BROWNS FERRY NUCLEAR PLANT, UNIT NO. 2

AMENDMENT TO FACILITY OPERATING LICENSE

Amendment No. 76
License No. DPR-52

ATTACHMENT TO LICENSE AMENDMENT NO. 76

THE OFFICE OF POWER
 ORGANIZATION FOR OPERATION
 OF NUCLEAR PLANTS
 Figure 5.2-1
 BROWNS FERRY NUCLEAR PLANT

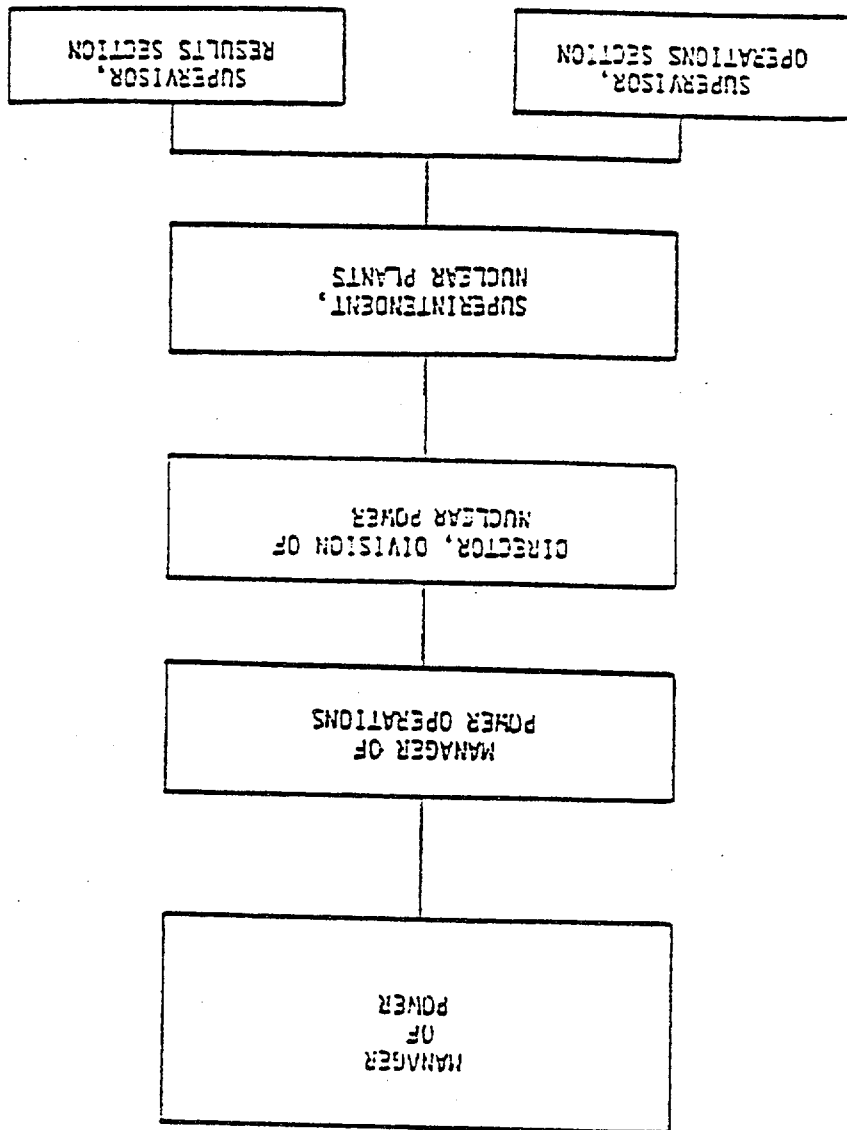
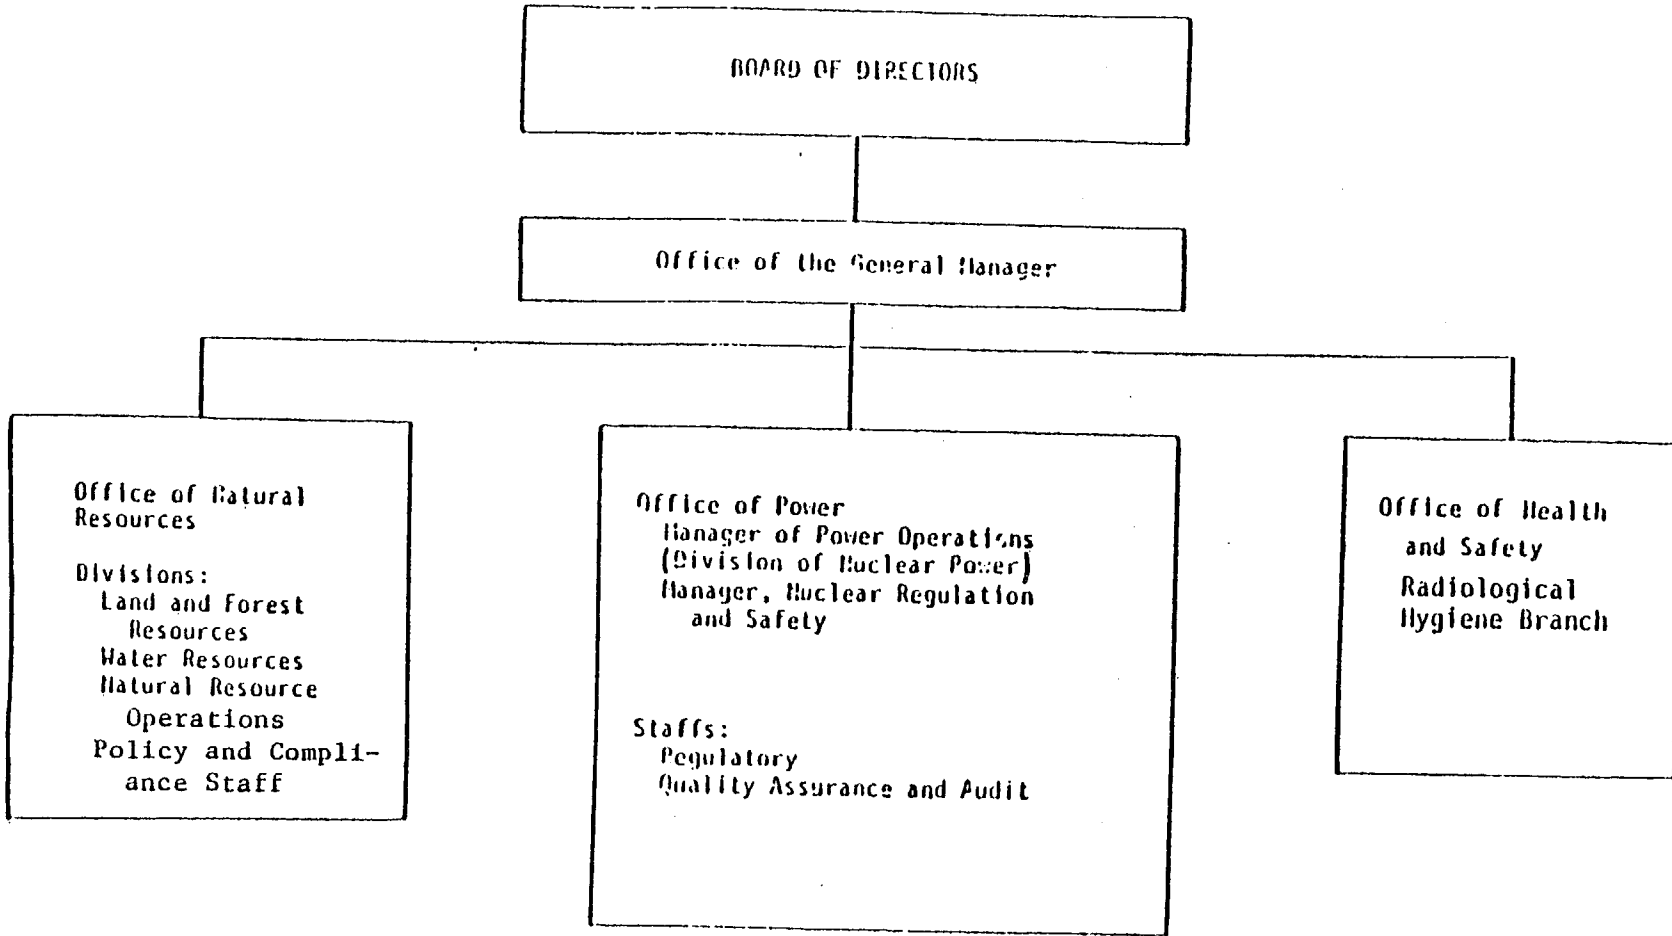
Operating requirements identified in Section 4.1 are duplicate to those conditions regulated by Browns Ferry Nuclear Plant's NPDES Permit No. ALO022080 which was issued to TVA on June 30, 1977. The NPDES permit specifies the specific effluent limitations for thermal, chemical, and sanitary waste discharges originating from the facilities and reporting requirements necessary to determine compliance with the effluent limitations. The existing limiting conditions of operation on water quality and the aquatic monitoring and reporting requirements are being deleted from the Browns Ferry Environmental Technical Specifications as a matter of law. Since the deletion of these conditions is a ministerial action required as a matter of law, no environmental impact assessment need be prepared as a condition precedent to taking this action. The changes to Section 5.0 - Administrative Controls to change the titles and organizational elements within TVA responsible for environmental activities is being made to reflect recent organizational changes within TVA.

- 5.2.1 The organization of TVA management which directly relates to operation of the plant is shown on Figure 5.2-1.
- 5.2.2 The principal organizations within TVA which are concerned with environmental matters related to nuclear power plant operations are the Office of Power, Office of Natural Resources, and the Office of Health and Safety. The Office of Power is directly responsible for operating the plant in accordance with specified requirements and conducting onsite monitoring. The Office of Natural Resources and the Office of Health and Safety are responsible for providing technical guidance, assistance, monitoring, and other services as needed for environmental compliance. The organizations above report to the General Manager as shown in Figure 5.2.1.
